PLANNING COMMISSION STAFF REPORT

MEETING DATE: December 5, 2011 **REPORT REVISED:** November 27, 2011
ITEM NUMBER: V.A. – PUBLIC HEARING
FILE NUMBER: **DRB-07-11 / Branagh Development, Inc. (Applicant), Kimberly LLC (Owners) 8 Kimberly Drive:** Consideration of a design review application for a new 2,995 square foot single story home with an attached 837 square foot 3-car garage on a 74,762 square foot lot at 8 Kimberly Drive. (APN 255-120-010).
ZONING: Zone OS-M (Open Space-MOSO)
CEQA STATUS: On June 7, 1999, the Planning Commission issued a Mitigated Negative Declaration of Environmental Impact under CEQA Guidelines Section 15074. The mitigation measures contained in this Mitigated Negative Declaration are still applicable to the project.

1. Slope

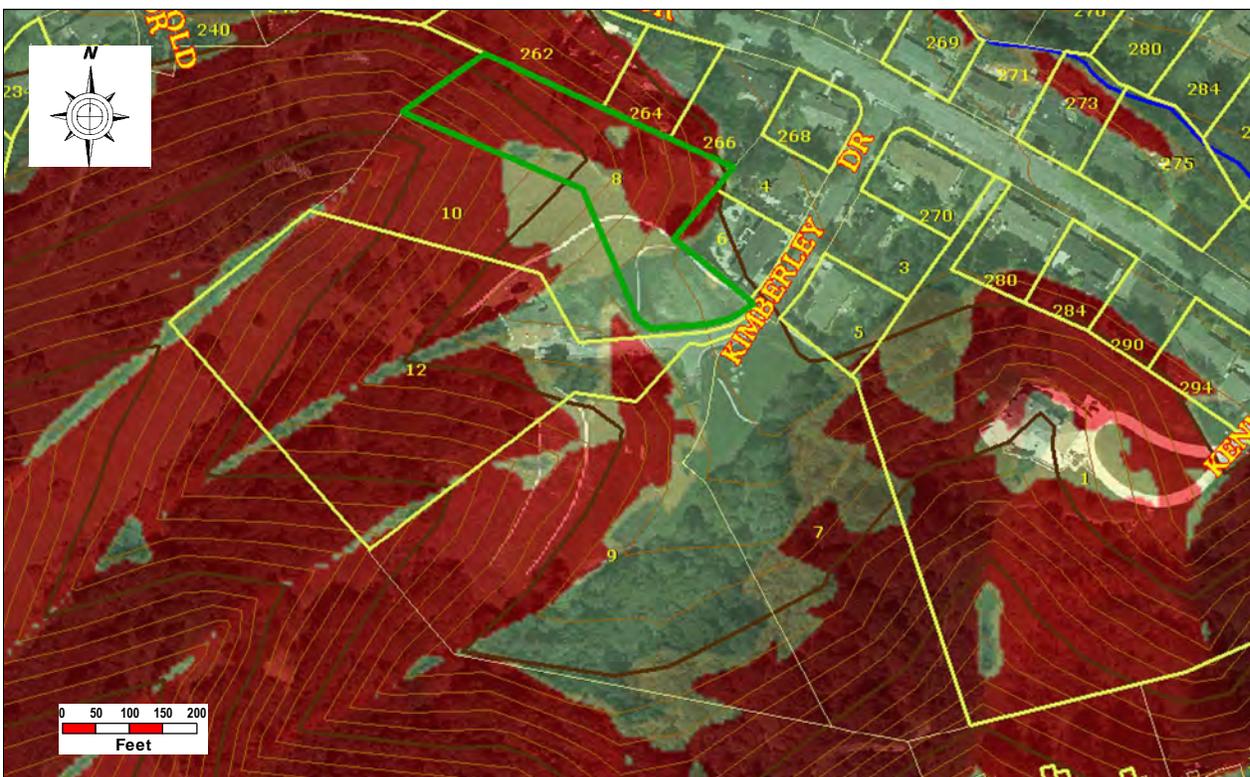
Chapter 8.136 of the Moraga Municipal Code (MMC) applies to any project with a slope of 20% or greater. Although the average slope within the “building cell” is less than 20%, a hillside development permit would still be required because there would be grading and alteration of a slope greater than 20%. The GIS slope map below shows the average slopes on the lot.

Jensen - Van Lienden Associates, Inc.		
Test Boring Locations 8 Kimberly Drive (Lot 1)		
Date 9/11	Figure 1	Job No. P170CC

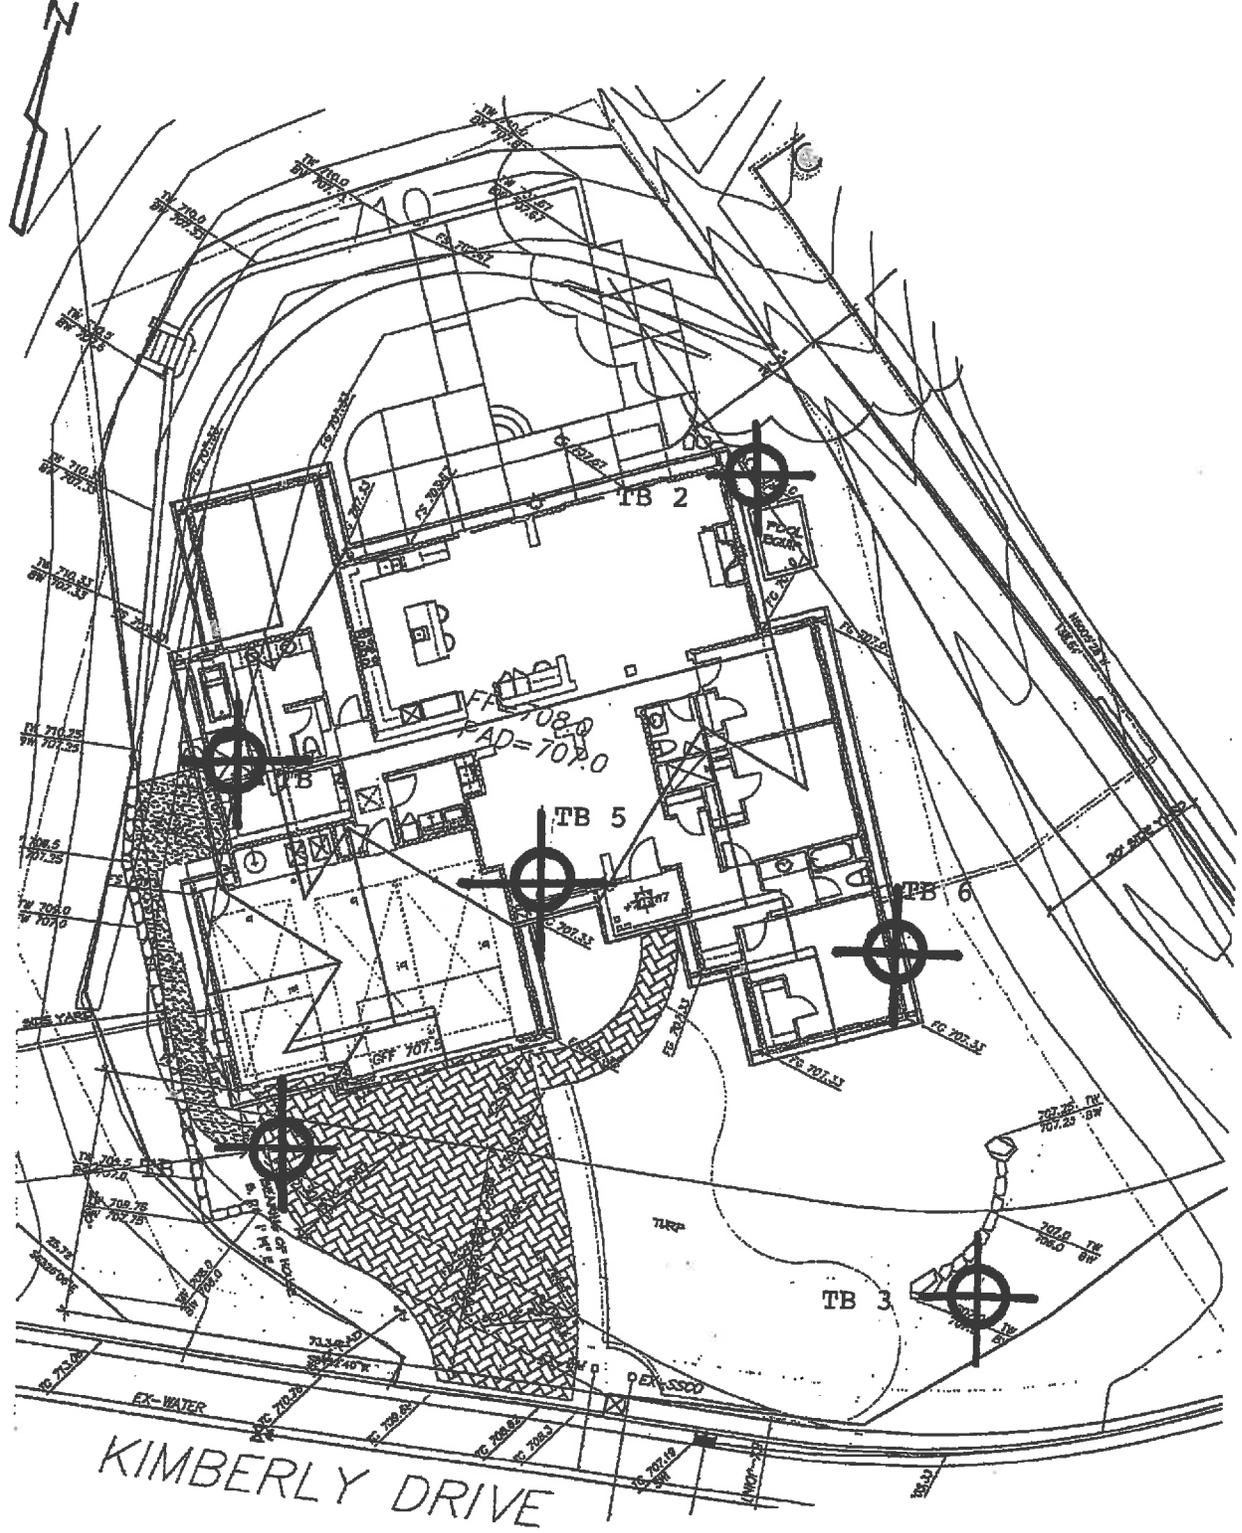
The building area has already been graded. We drilled 3 shallow test borings on the pad in the area of the proposed new house. Our project engineer in the field classified the soil conditions encountered in the borings. The locations of the new borings (borings 4 through 6) are shown on the attached site plan, Figure 1. Logs of all of the borings are presented on Figures 2 through 7.
